Load Binder Securement

| Model: See below Serial #: N/A | Dec. 4, 2017 |
| Alert | |

Figure 2: Load Binder with Safety Securement

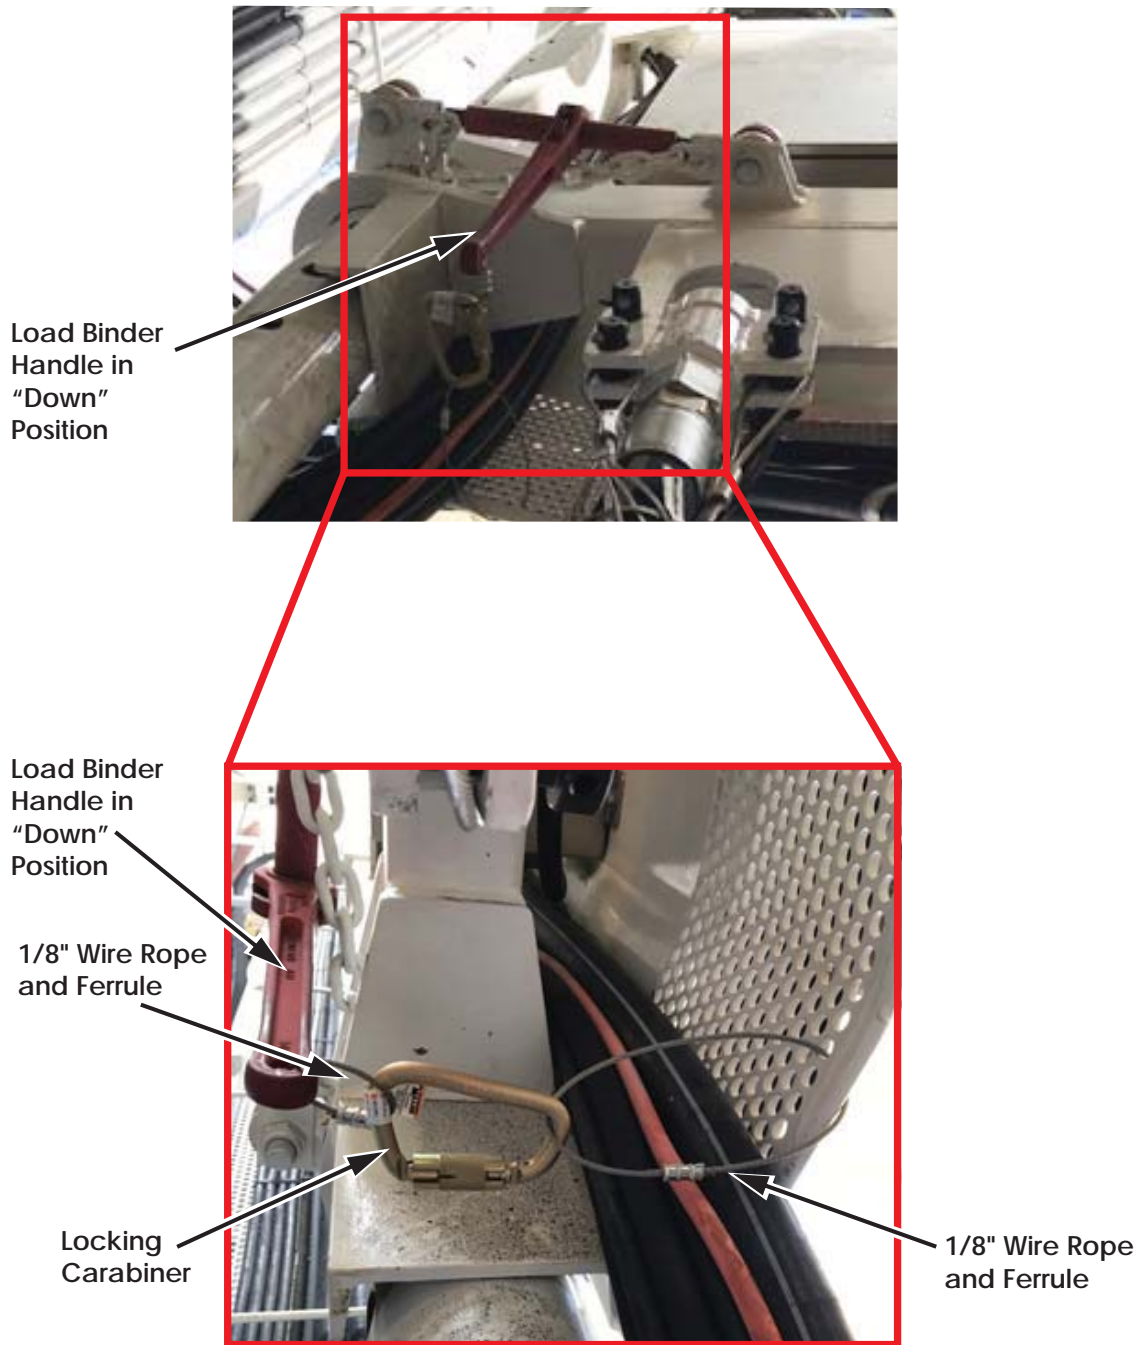
The Load Binder that positions the mast services j-box on a portable torque guide can become detached. If the Load Binder is not centered between the attachment points, there is a risk one of the threaded rods could become disengaged. See Figure 1.

2. Check the Load Binder to ensure there are equal number of threads exposed on the two threaded rods on either end of the Load Binder. Refer to the Figure 1 on page 1 for reference. If necessary, reposition the Load Binder so that the Load Binder is in center position between the mounting bolts.
3. Ensure Load Binder handle position is down and out of the path of the top drive or any other moving object. See Figure 2 on page 3.
4. From kit AY23475:
 - add a safety securement to the Load Binder using 1/8" wire rope (Canrig P/N: M10022),
 - 1/8" ferrule (Canrig P/N: M19-3009-010),
 - and locking carabiner (Canrig P/N: M12988) as shown in Figure 2 on page 3.
5. Ensure a minimum amount of slack for the 1/8" wire rope so it is not a potential snag point.

1. Contact RIGLINE 24/7™ Support to order the kit:

| Canrig P/N | Description |
|------------|-------------------------------------|
| AY23475 | KIT, SAFETY SECUREMENT, Load Binder |
